SUBJECT: Fuel Manifold Drain
MODELS AFFECTED: M20E S/N 231 thru 746
TIME OF COMPLIANCE: At the next 100 hour inspection

SERVICE LETTER NO. 20-132

FIGURE 1.

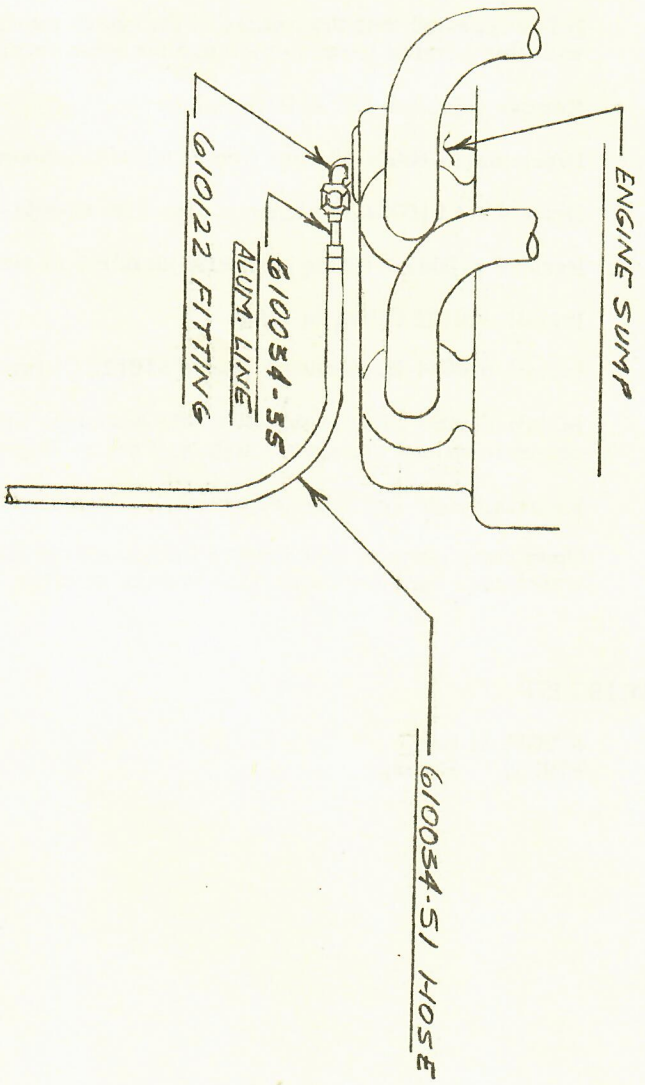
- INSTRUCTIONS:
1. Remove right and left side engine cowls.
 2. Disconnect 610034-39 hose from 610034-35 aluminum line.
 3. Disconnect 610034-35 aluminum line from 610041-1 fitting.
 4. Remove 610041-1 fitting presently installed in sump.
 5. Install 610122 fitting in sump.
 6. Install 610034-35 aluminum line in 610122 fitting.
 7. Install 610034-51 hose on 610034-35 aluminum line making sure all connections and clamps are tight and are as Figure 1.
 8. Reinstall right and left side engine cowls previously removed.
